Review of Existing Licence

Division 3, Part V *Environmental Protection Act 1986*

Licence number	L5319/1988/12
Licence holder	Tronox Management Pty Ltd
ACN	009 343 364
File number	DER2015/000793
Premises	Cooljarloo Mineral Sands Mine 12051 Brand Highway COOLJARLOO WA 6507 Legal description – Mining Lease M70/268A
Date of report	23 December 2019
Status of report	Final

Figure 4: Location of black waste pits and associated monitoring bores.

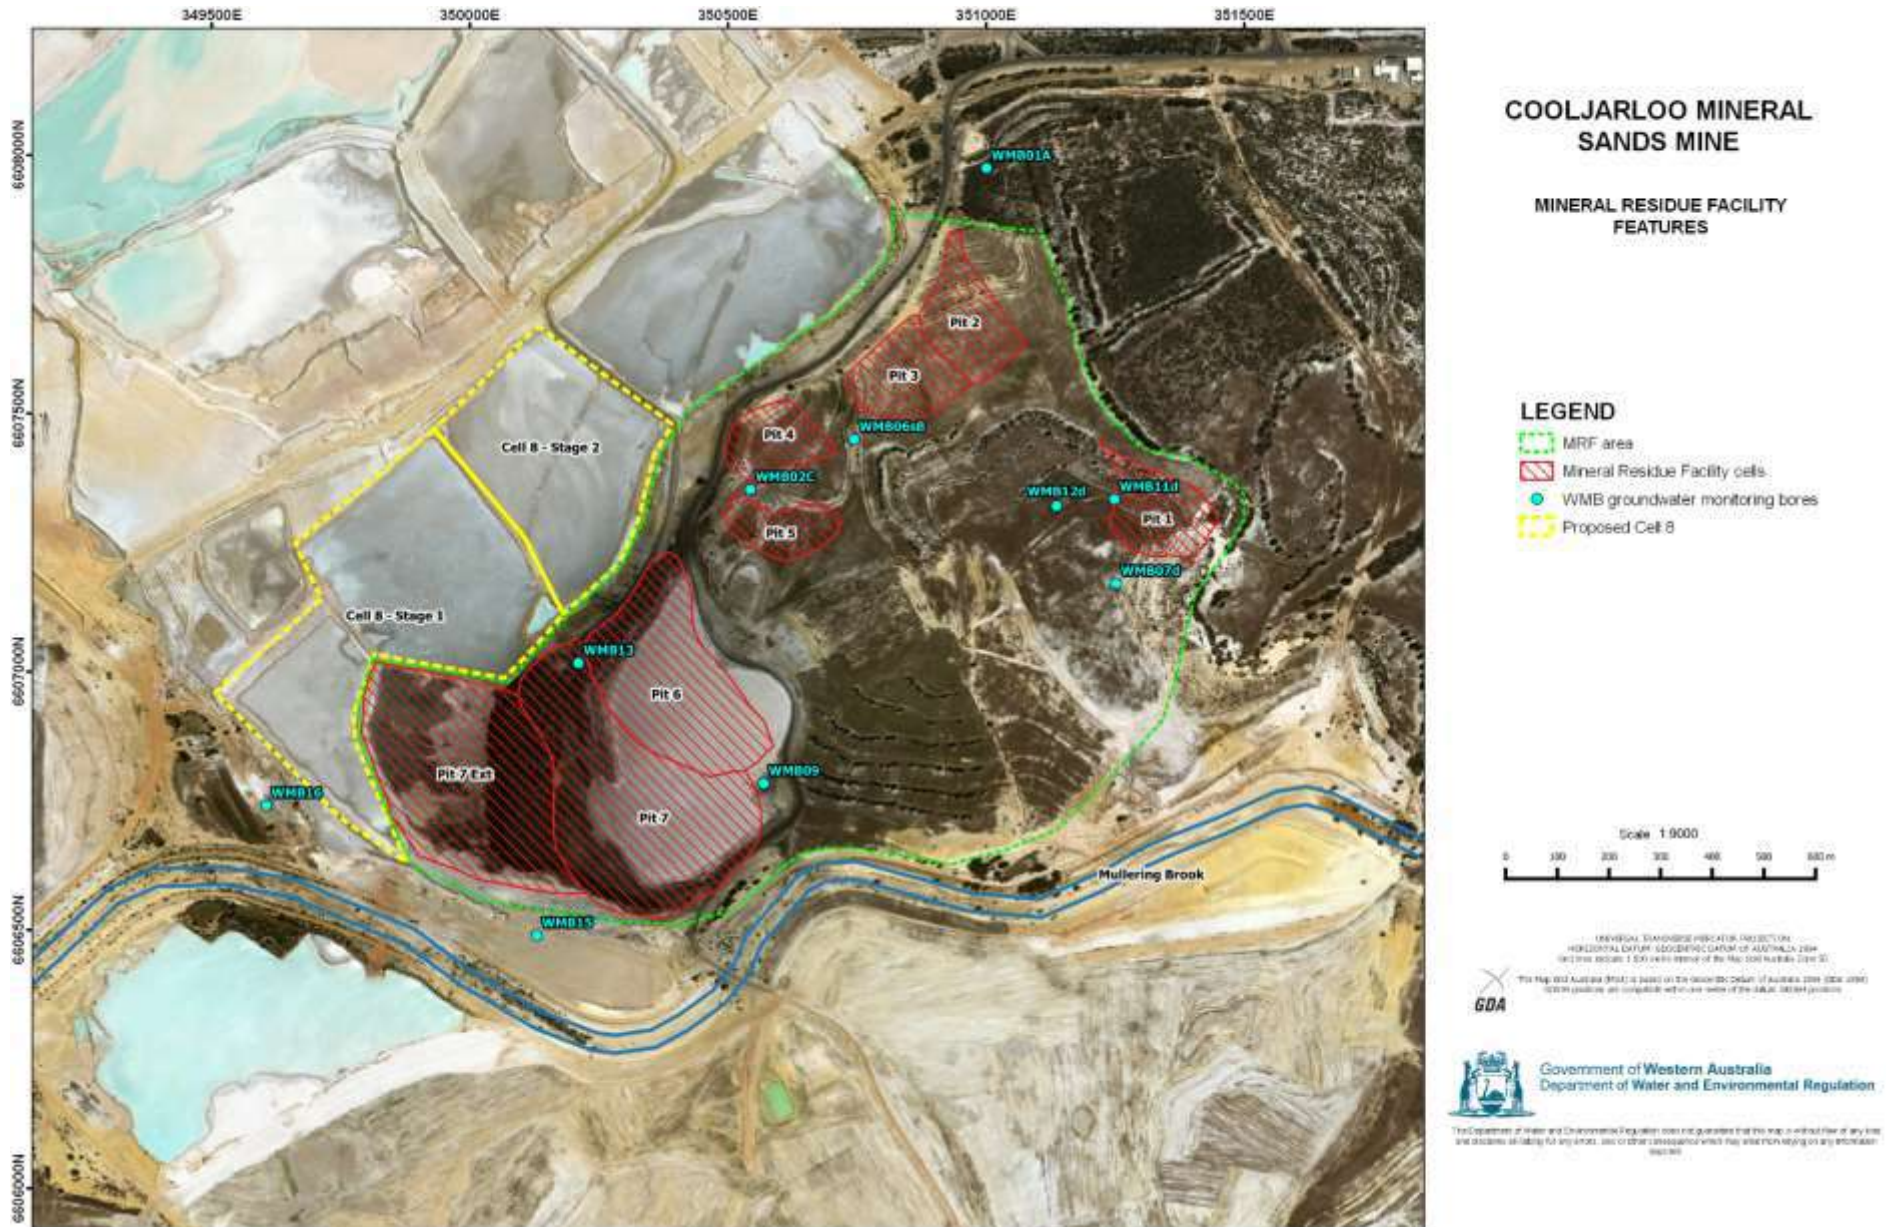
The WMB series of bores, located in proximity to the MRF, indicate a slightly acidic to neutral pH (6 – 7.25) and an increasing trend in groundwater salinity, although the majority of the salinity values are within the historical range. However as noted by PPK (2001), the

distribution of the WMB series of bores in relation to the black waste pits does not provide a clear understanding on groundwater impacts caused by the waste pits. Waste Pit 1 is currently over-monitored and there is minimal information being collected from the other pits, particularly downgradient of Waste Pits 6 and 7. Additionally, in the absence of detailed hydrogeological information, there is considerable uncertainty as to whether the bores are suitably located and constructed to detect leachate that might discharge from the waste pits, particularly the earlier (unlined) pits.

4. The current WMB series of monitoring bores does not provide a clear understanding on groundwater impacts caused by the black waste pits. In addition, there are large gaps in the chemical analyses carried out in groundwater samples from these bores – it is therefore unclear whether groundwater near these bores contains concentrations of metals and metalloids at levels of environmental concern.

Figure 11: pH of the dredge pond 2005 – 2016

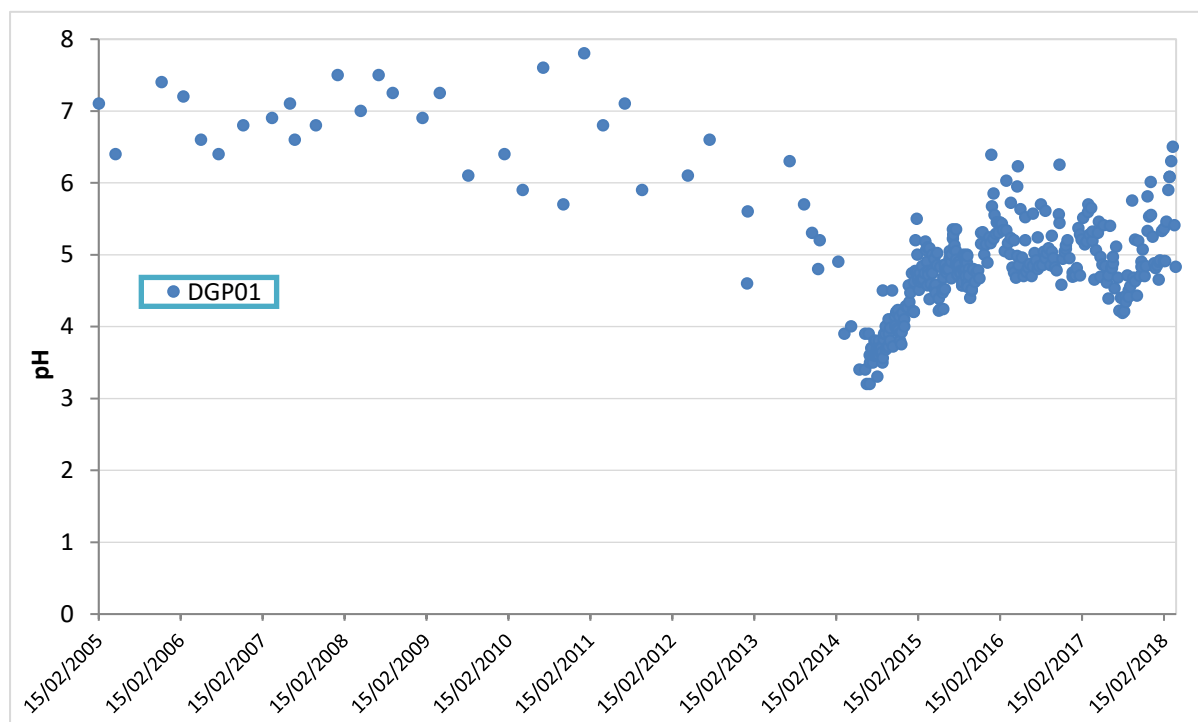
From the end of 2011 the pH of the dredge pond started to drop, followed by a rapid decrease to around pH 3.1 in July 2013 (Figure 11). The lack of a buffering response following the addition of a significant quantity of neutralising agent (lime putty) prompted a targeted investigation into the key driver causing the observed acidity.

DWER's review of the South Mine ASS Management Plan (SWC, 2015), which includes baseline, pre-screening work undertaken in current and future mine areas, as well as results from the targeted investigation into the acidification of the dredge pond, identified that:

- in addition to pH measurements, measure the total acidity and total alkalinity of the water in the field (i.e. using commercial test kits that are cheap and simple to use). This is because changes in acidity and alkalinity are typically seen in an acidifying water body long before pH changes take place (i.e. management response such as increasing lime dosing can be implemented more quickly by measuring these parameters). In particular, water that has an alkalinity of less than 10 – 30 mg/L $CaCO_3$ has the potential to experience large pH declines with the input of small amounts of acidity. It is also recommended the alkalinity of the dredge pond is maintained above 30 mg/L $CaCO_3$ to reduce the risk of further acidification taking place.
